UNITED STATES PATENT AND TRADEMARK OFFICE

10/529,384

Office Action Summary	Application No. 10/529,384	Applicant(s) BANDO, KAZUAKI	
	Examiner ROBERT SCRUGGS	Art Unit 3723

DETAILED ACTION

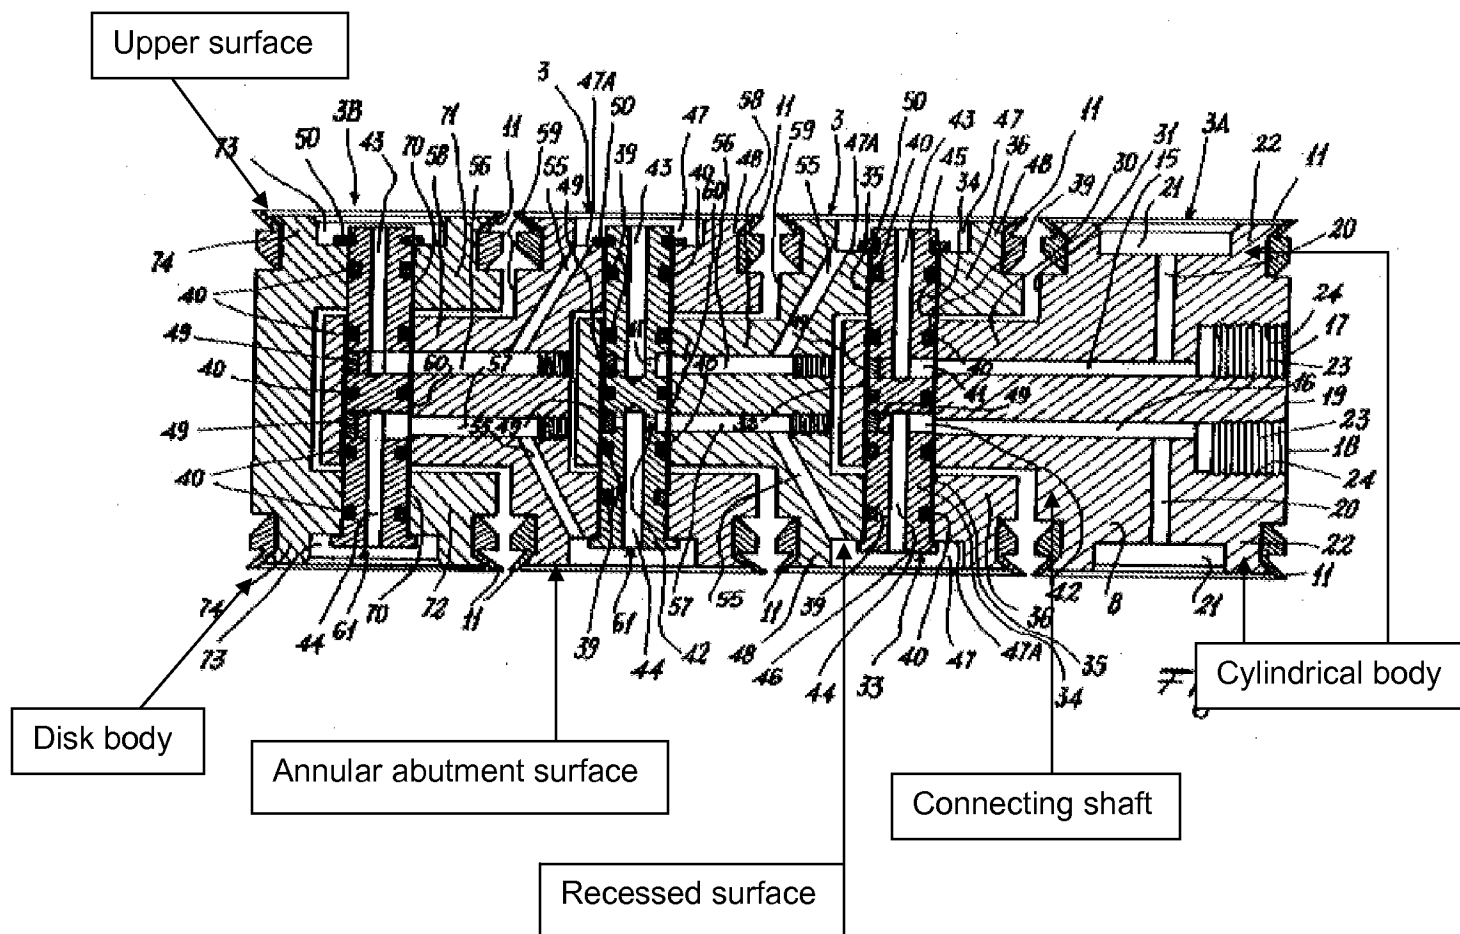
In reference to claims 17, 18, 23 and 24, Bovone also discloses a suction cup formed with an annular abutment surface (see figure below), a recessed surface (see figure below) held by suction (through lines 15, 16, 20, 55, 56).

Monforte (4809425). Bando in view of Bovone and Ercole et al. disclose the claimed invention previously mentioned above and Bovone further teaches that the suction cup includes a cylindrical body whose upper surface (see figure below) is covered with an elastic member (11) for abutment against the glass plate (1), a disk body (bottom portion) (see figure below) for abutment against said grinding supporting table and a connecting shaft (see figure below) which connects said disk body and said cylindrical body, but is silent in having a lifting device formed with grippers that move toward or away from each other. However, Monforte teaches that a robotic arm can be formed with multiple types of end effectors (Figures 3a-3h) and that they are all equivalent of one another where one such arm includes grippers (Figure 3f) (210) that move toward and away from one another. It would have been obvious to one of ordinary skill in the art at the time the invention was made to modify the arranging means, of Bando, with a lifting device formed with grippers (instead of a pin) that move toward or away from each other, in view of Monforte, in order to provide a lifting device that can pick up various size support elements and provide a stronger grasp on the selected element.
